NEWMAR CORPORATION WARRANTY DEPARTMENT

TECHNICAL SERVICE BULLETIN																			
DATE ISSUED		MODEL YEAR(S) AFFECTED			MODEL(S) AFFECTED			TSB #											
8/6/93		1992-1993			ALL			83											
BRAND					TYPE														
All	<input type="checkbox"/>	American Star	<input type="checkbox"/>	Kountry Star	<input checked="" type="checkbox"/>	Dutch Star	<input type="checkbox"/>	All	<input type="checkbox"/>										
NewAire	<input type="checkbox"/>	Mountain Aire	<input checked="" type="checkbox"/>	Kountry Aire	<input checked="" type="checkbox"/>	London Aire	<input checked="" type="checkbox"/>	T T	<input type="checkbox"/>										
								F W	<input type="checkbox"/>										
								C A	<input checked="" type="checkbox"/>										
								D P	<input type="checkbox"/>										
								D B	<input type="checkbox"/>

GROUNDING INSTRUCTIONS 610 CONTROL BOX

GROUND CABLE INSTALLATION FOR STONE PUMPS

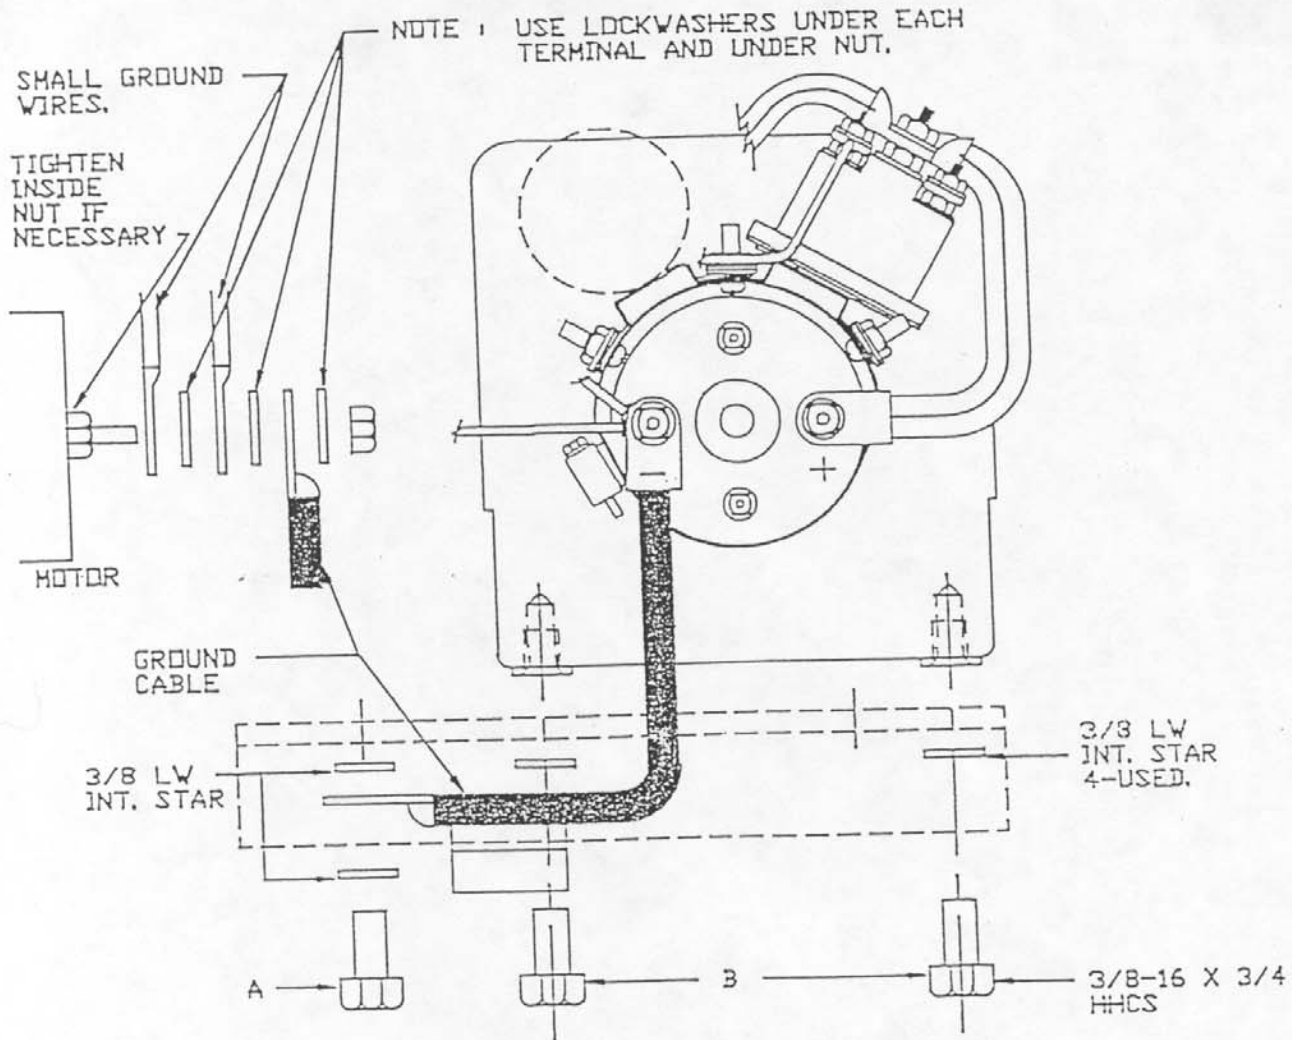
CONNECT GROUND CABLE STRAP FROM NEGATIVE ("−")
MOTOR TERMINAL TO PUMP CHANNEL MOUNTING BOLT (A).
IF PUMP CHANNEL IS WELDED TO FRAME, CONNECT
GROUND CABLE STRAP TO A PUMP MOUNTING BOLT (B).
A 3/8 INTERNAL STAR LOCKWASHER MUST BE USED
BETWEEN GROUND CABLE STRAP TERMINAL/PUMP CHANNEL
AND BETWEEN GROUND CABLE STRAP TERMINAL/BOLT HEAD
OR NUT.
